From: Mess, Camie
Sent: Wednesday, April 25, 2018 5:18 PM
To: Tim Tessier (tt@bdarchitects.com)
Cc: Werner, Jeffrey B
Subject: BAR Actions - April 17, 2018 - 809 Rugby Road

BAR 18-04-02
809 Rugby Road
Tax Parcel 050011000
Andrew and Dixie Mills, Owner/Tim Tessier, Applicant
Renovation and screened porch

**CITY OF CHARLOTTESVILLE
BOARD OF ARCHITECTURAL REVIEW
STAFF REPORT
April 17, 2018**

RENOVATION AND SCREENED PORCH ADDITION

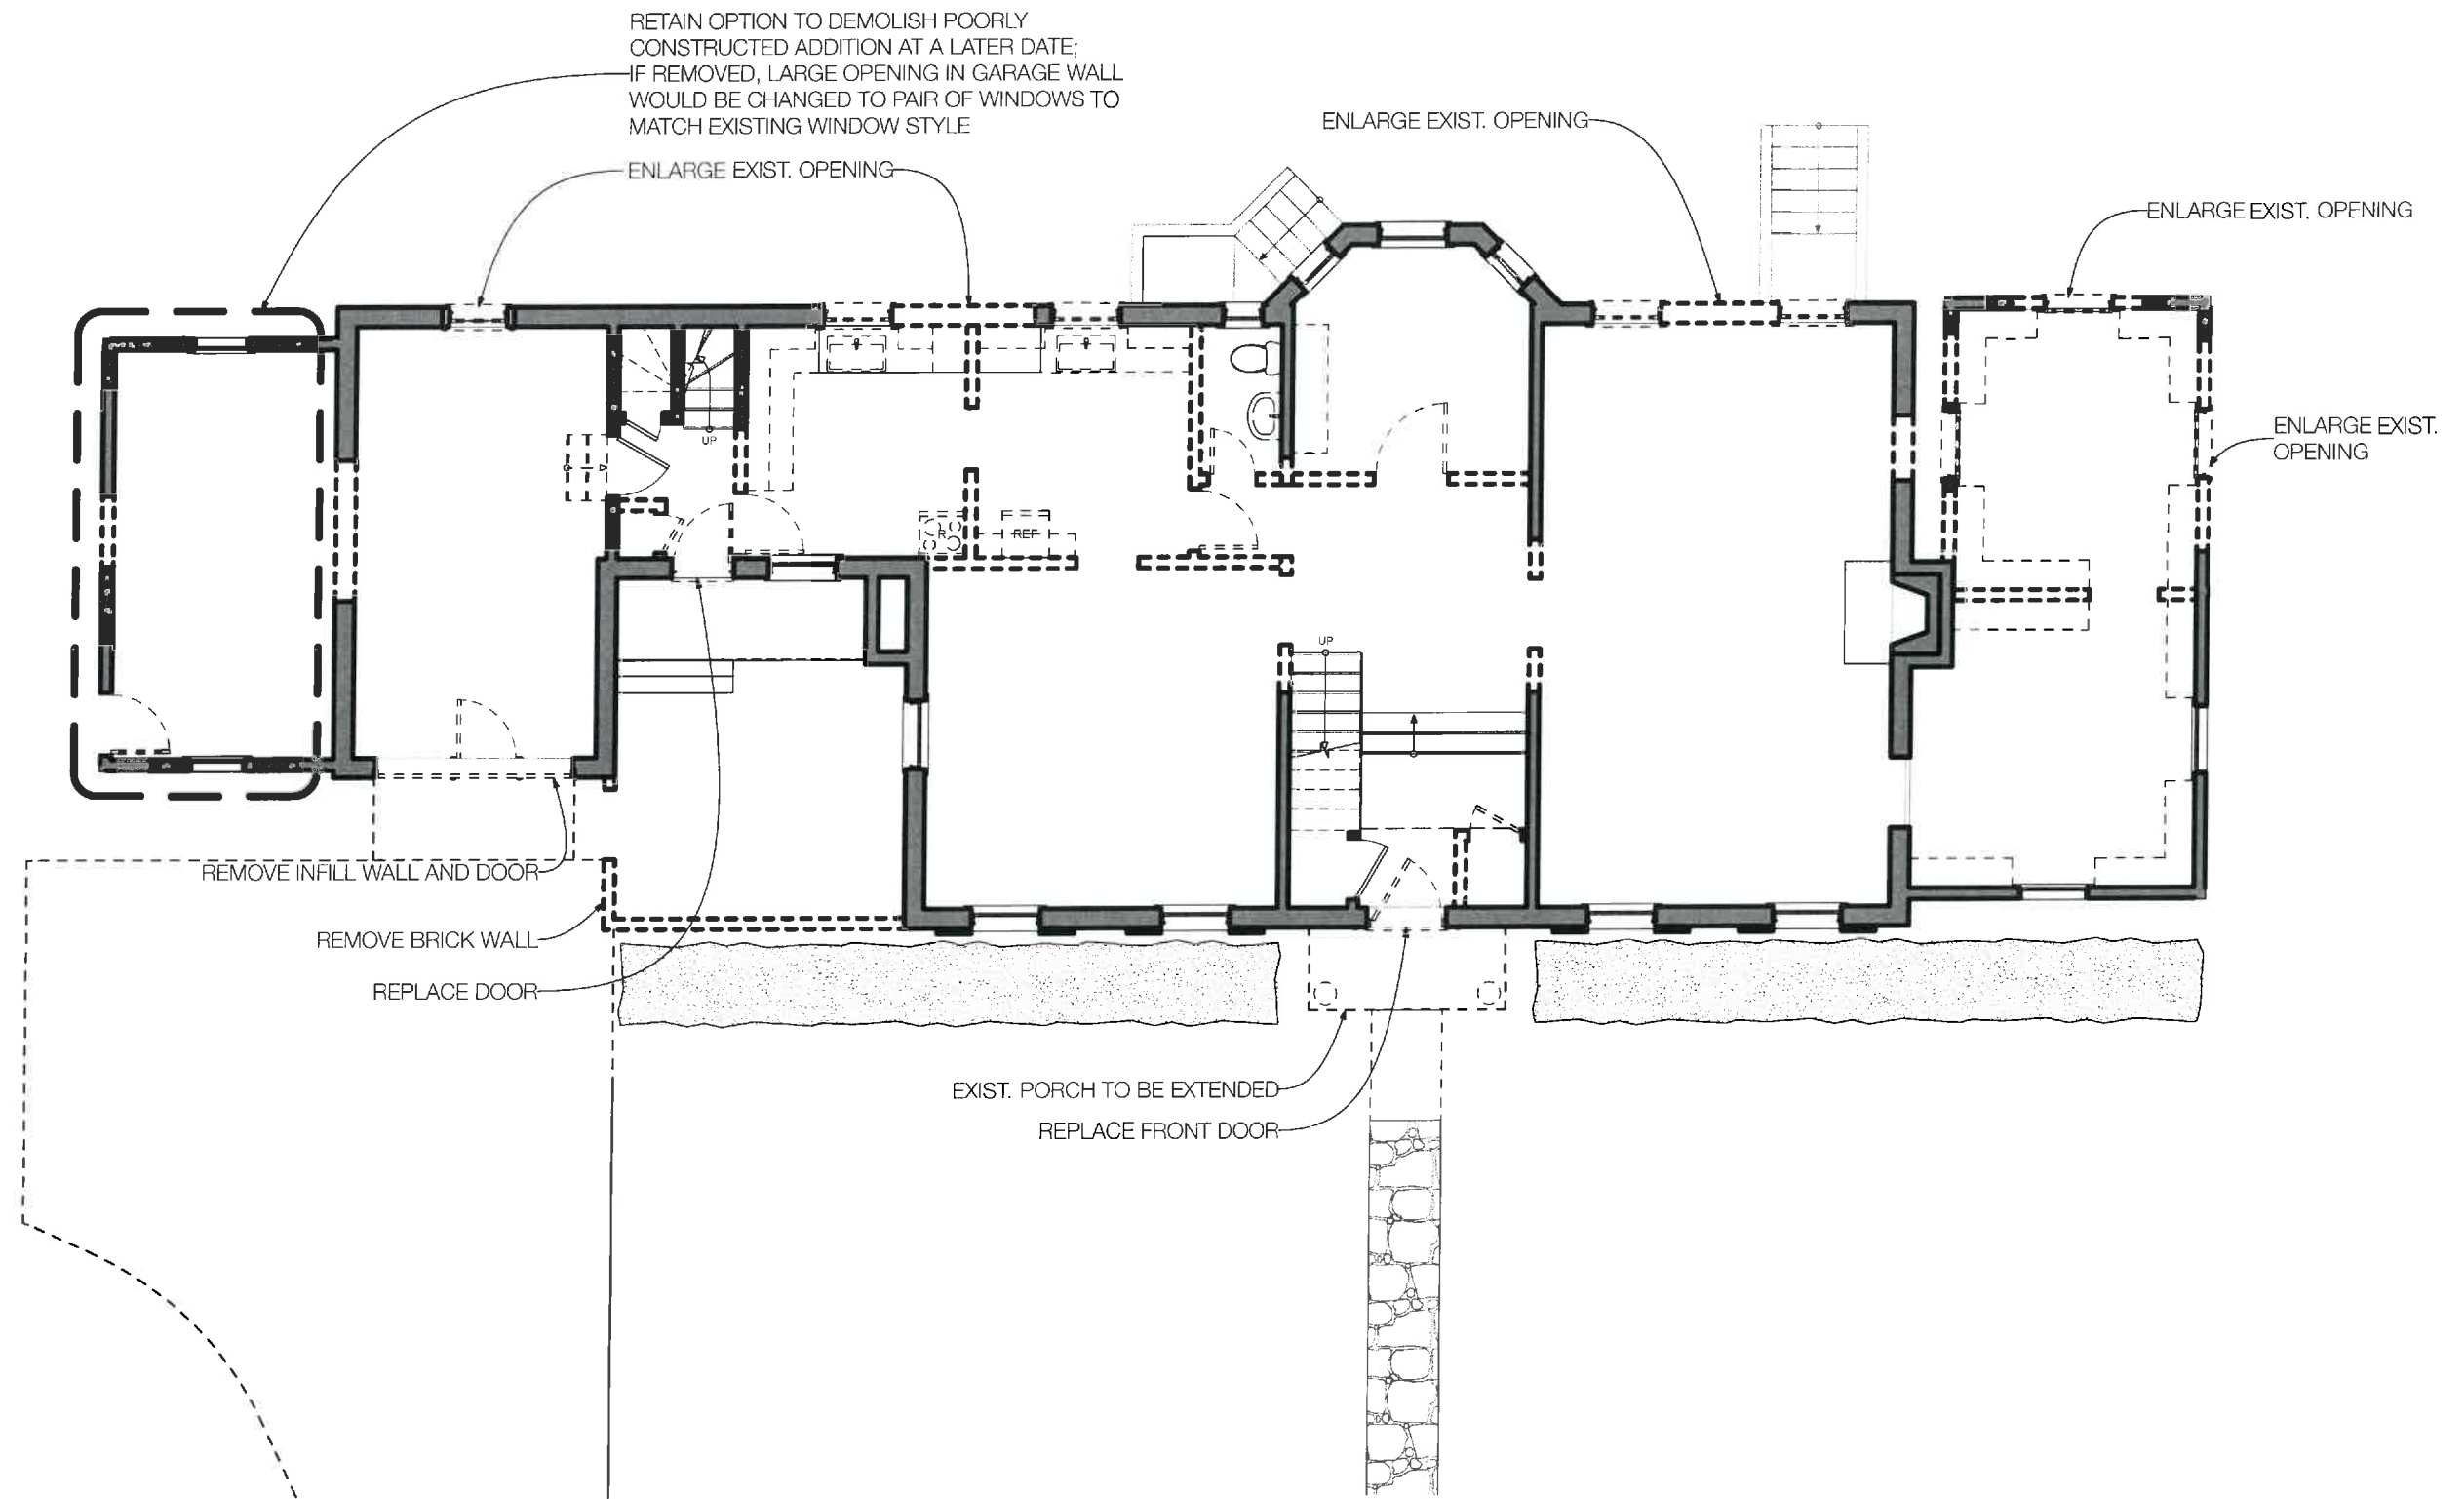
REVISE ASPHALT PARKING AREA

- **two parking spaces off of Winston Road**
- **shed structure at west side of garage to have double doors**
- **replacement windows to be aluminum clad**
